Bulletin Number: DF 4-04

Burner Supply Tube Compression Fitting Nuts

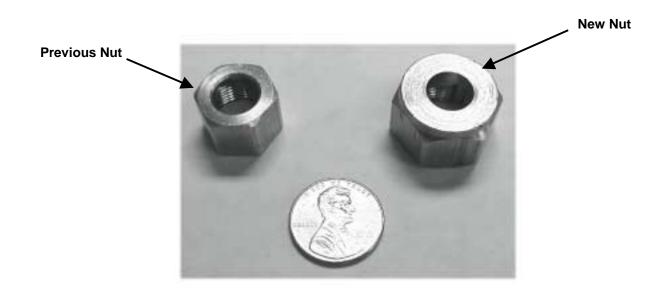
We have received complaints from several customers that the burner supply tube compression fitting nuts have cracked on some units after a season or two of use. These are the fittings that connect the low pressure copper tube to the burner. The cracks are developing as a result of thermal stress in severe environments.

As a result, Algas-SDI has initiated the use of a heavier duty compression fitting and nut. The new nut requires the use of a 13/16" open-end wrench or flare-nut wrench for servicing, whereas the previous nut required a 5/8" wrench. The new nut has an increased wall thickness of 0.10"

The manufacturing effective date is April 1, 2004 for all units.
